# Technical Service Information

## LEXUS A341E HARSH 3RD AND REVERSE

Figure 1

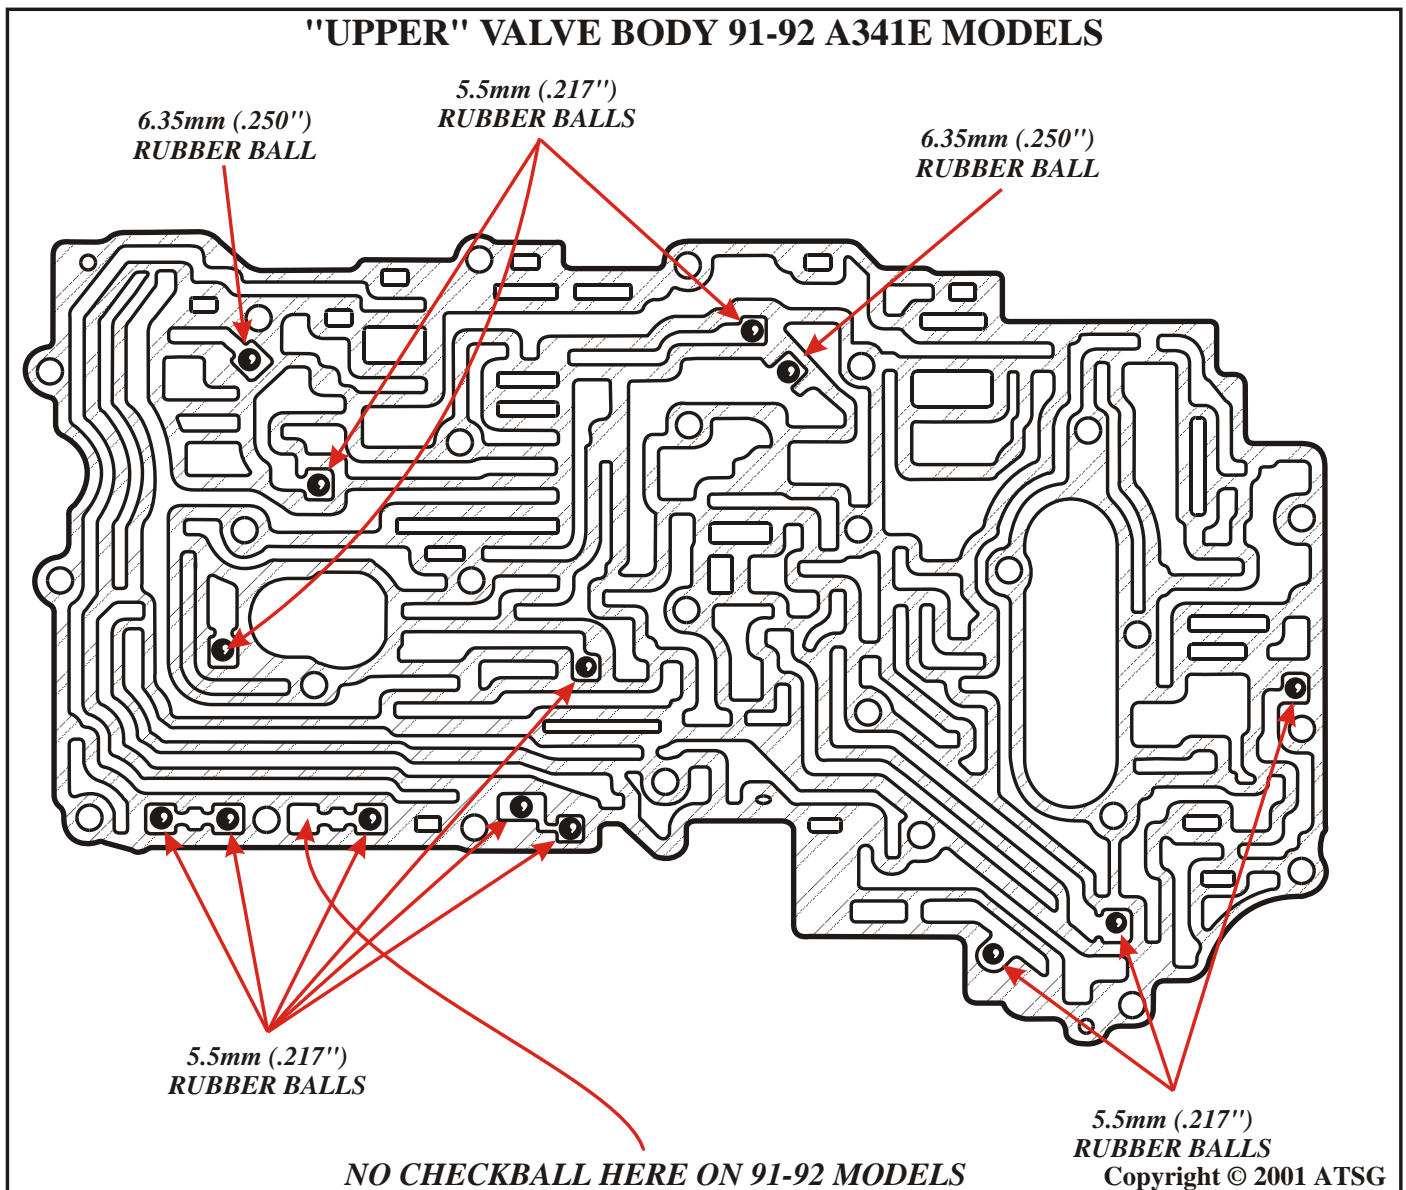
**COMPLAINT:** After overhaul, some 1991-1992 model Lexus equipped with A341E transmissions, may exhibit a harsh upshift into 3rd gear and a hard application into Reverse.

**CAUSE:** The cause may be, a check ball was added to the Upper Valve Body for the 93 and up checkball locations as shown in Figure 2. When this happens, the C2 or Direct clutch can apply at a faster rate, because the passage to the C2 or Direct accumulator piston is restricted by the ball.

**CORRECTION:** Refer to Figure 1 for the correct checkball location for 1991-92 model applications and Figure 2 for 1993 and later models.
